California Public Utilities Commission Gorman-Kern River 66 kV Project Final Initial Study/Mitigated Negative Declaration

March 2025

This chapter includes copies of the comment letters received during the public review period on the Draft IS/MND for the proposed Transmission Line Rating Remediation Gorman-Kern River 66 kV Project (Project), Application A.22-02-014, and the responses to those comments.

Figure 3.13-1 Nearest Residential Sensitive Receptor by Proposed Project Segment (Map 1 of 5)

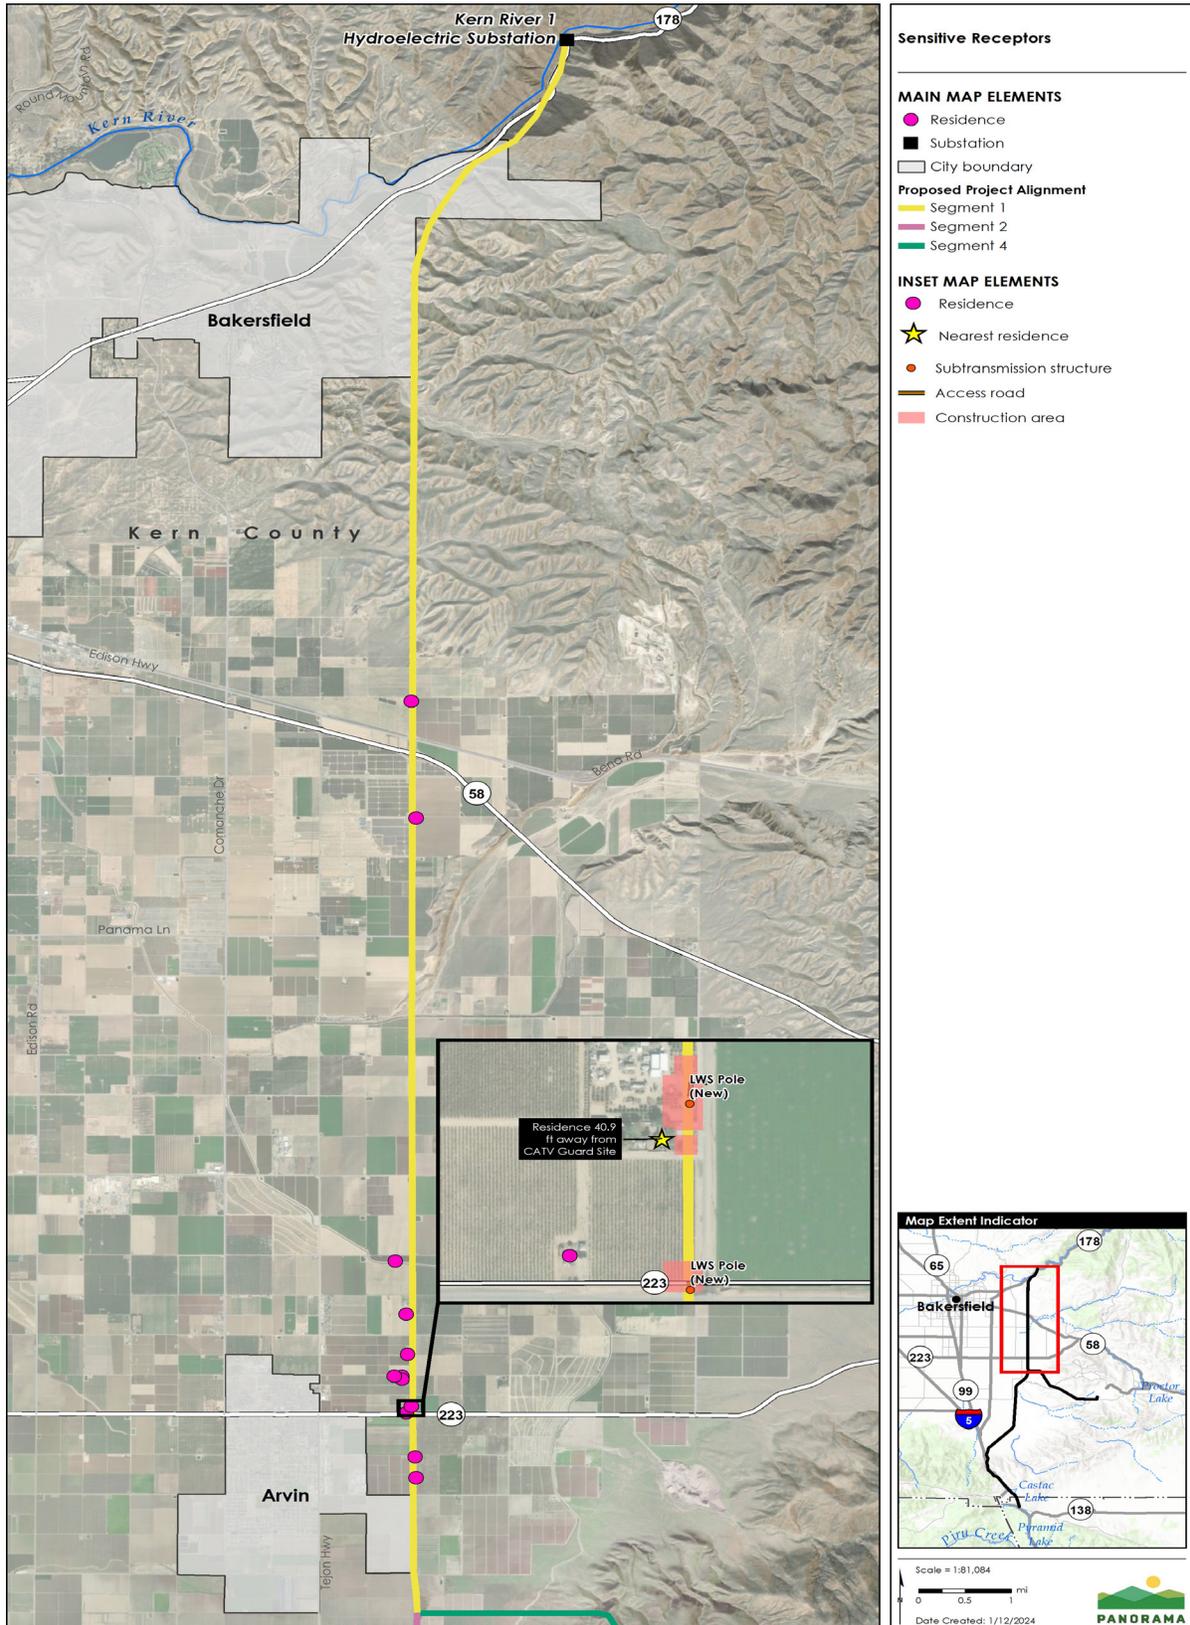
| Chapter | Page | IS/MND Language | SCE Recommendations |
|-----------|---------|---|---|
| Chapter 3 | 3.13-8 | Figure 3.13-1: Nearest Residential Sensitive Receptor by Proposed Project Segment (Map 1 of 5) | Comment: Map is misaligned. Proposed Revision: Align Map |

The comment states that Figure 3.13-1, Nearest Residential Sensitive Receptor by Proposed Project Segment (Map 1 of 5), is misaligned. Please see the updates to the figure that corrects the alignment.

Figure 3.13-3 Nearest Residential Sensitive Receptor by Proposed Project Segment (Map 3 of 5)

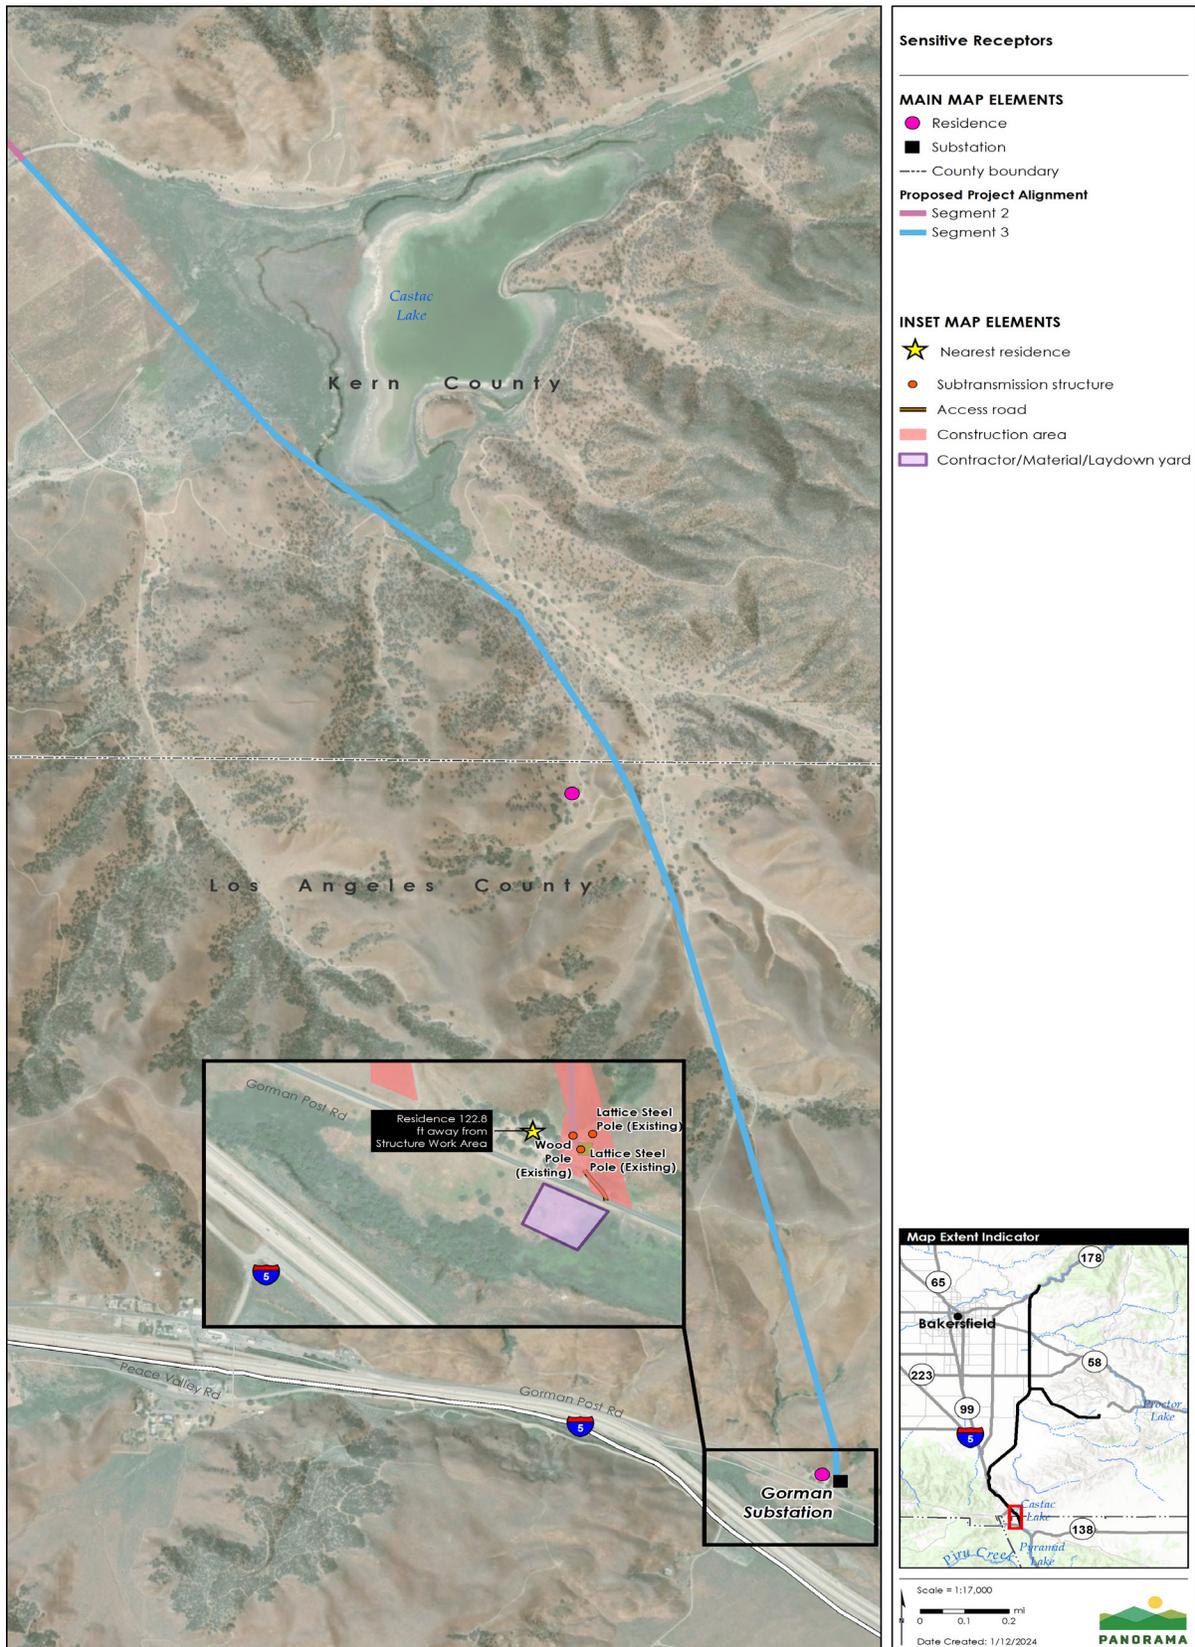
| Chapter | Page | IS/MND Language | SCE Recommendations |
|-----------|---------|---|---|
| Chapter 3 | 3.13-10 | Figure 3.13-3: Nearest Residential Sensitive Receptor by Proposed Project Segment (Map 3 of 5) | Comment: Map is misaligned. Proposed Revision: Align Map |

The comment states that Figure 3.13-3, Nearest Residential Sensitive Receptor by Proposed Project Segment (Map 3 of 5), is misaligned. Please see the updates to the figure that corrects the alignment.
